TO: Russell D. Huyck NYS Department of Environmental Conservation Route 86 - P.O. Box 296 Ray Brook, NY 12977	DATE 2/25/2005 PROJECT NO: 04.9498 RE: Site Investigation Work Plan - Addendum #1 Durkee Street Parking Lot Plattsburgh, New York
--	--

Re: Response to February 4, 2005 NYSDOH/DEC Comment Letter  
VCP Site Investigation Work Plan  
Addendum No. 1  
Durkee Street Parking Lot, Plattsburgh, New York  
C.T. Male Project No. 04.9498

**FIGURE 3**  
**SAMPLE LOCATIONS MAP**  
**PLATTSBURGH GATEWAY PROJECT**  
**DURKEE STREET PARKING LOT**

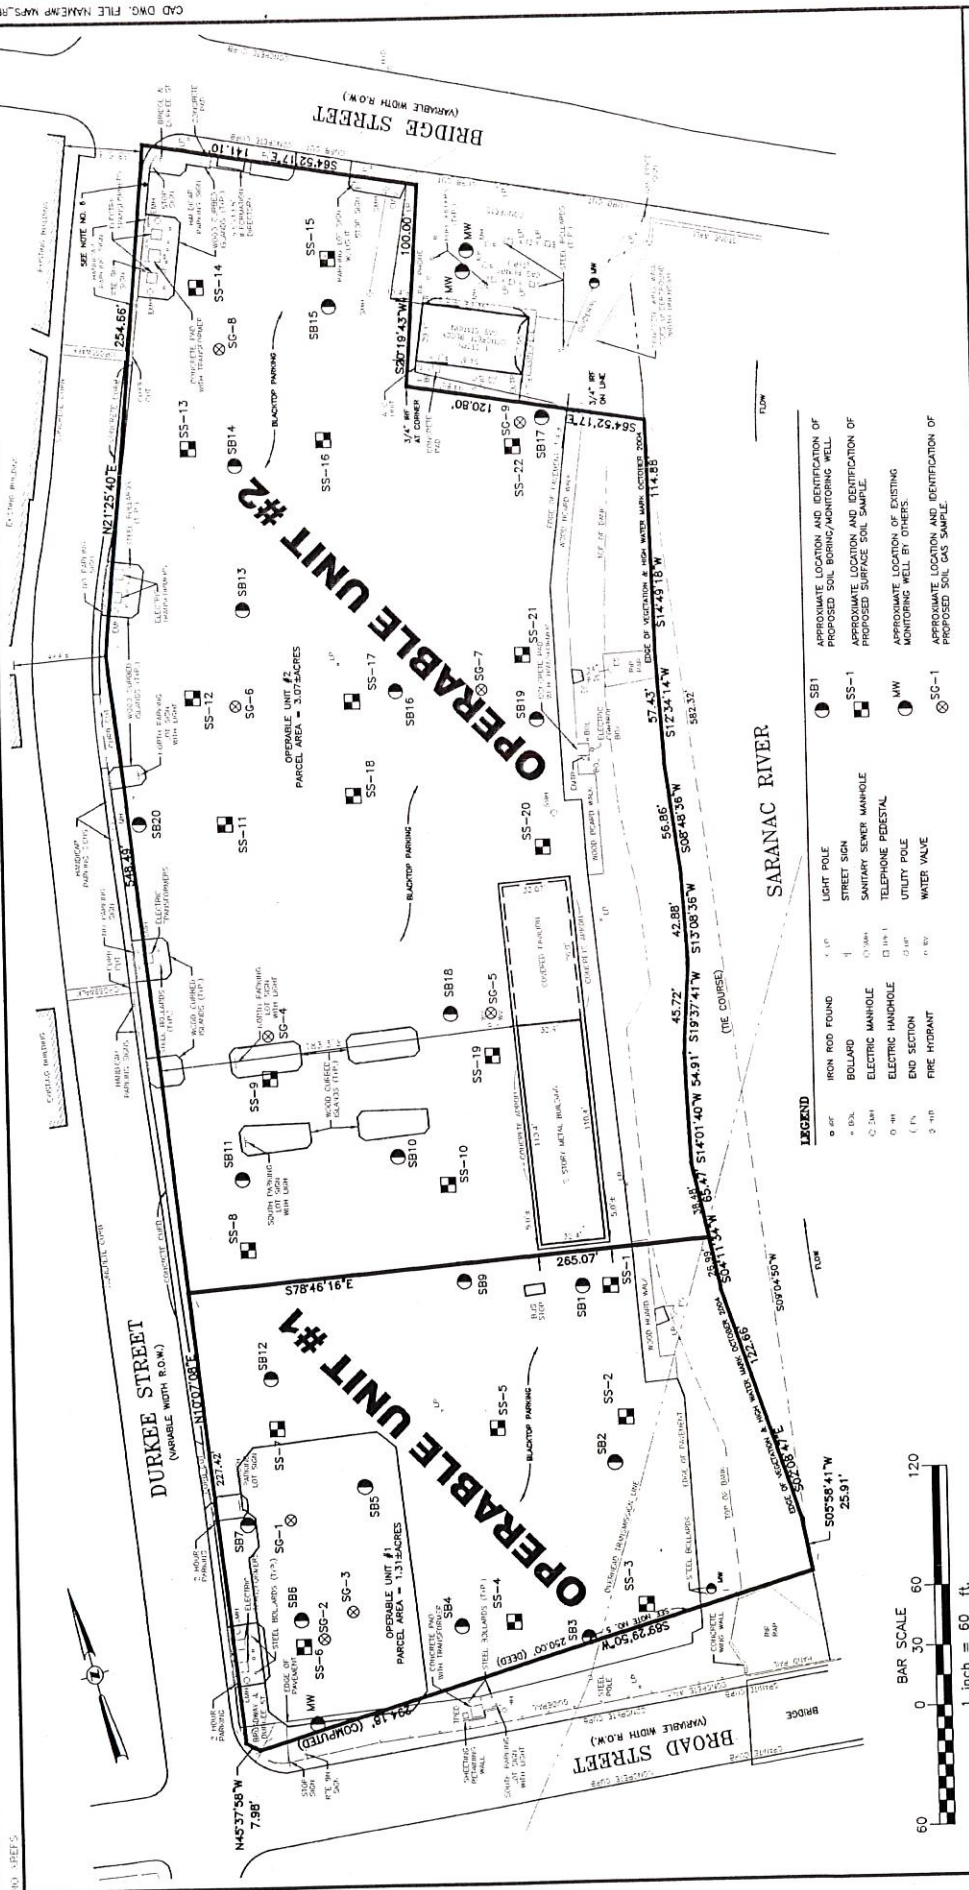
**DEC Comment:** *The appropriate figures contained within the Work Plan must be revised to include the locations proposed for the collection of soil gas samples. Actual field sampling locations and results must be documented and presented in the remedial investigation report.*

**DEC Comment:** *Please specify the number of soil gas samples to be collected from within the approximate footprint of the office building proposed to be located within OU1.*

*DEC Comment: A soil gas survey is not specifically proposed for OU2. An evaluation of soil gas within OU2 will be required. Please amend the work plan accordingly.*

**C.T. Male Response:** Attached is a revised Site Plan depicting the approximate locations of the completed soil gas sampling points within OU1 and identification of proposed soil gas sampling points within OU2. SG-1 to SG-3 are located in the footprint of the proposed office building slated for Operable Unit #1. The remaining six sample points will be placed at approximate equidistant locations within Operable Unit #2, which should provide adequate coverage for any future building construction in this area. If future building locations become known prior to the completion of the soil gas sampling within OU2, their locations may be adjusted accordingly.

**C.T. Male Response:** Three soil gas samples have been collected from within the footprint of the planned office building within OU1. The locations are depicted as SG-1 to SG-3 on the attached site plan. Ambient and duplicate samples were also collected as part of the sampling effort.

**C.T. Male Response:** Six soil gas sample points, placed at approximate equidistant locations, are proposed for Operable Unit #2. The sample locations should provide adequate coverage of this portion of the site should future development take place. The sample point locations are depicted on the attached site plan. Ambient and field duplicated samples will be collected as part of the sampling scheme.
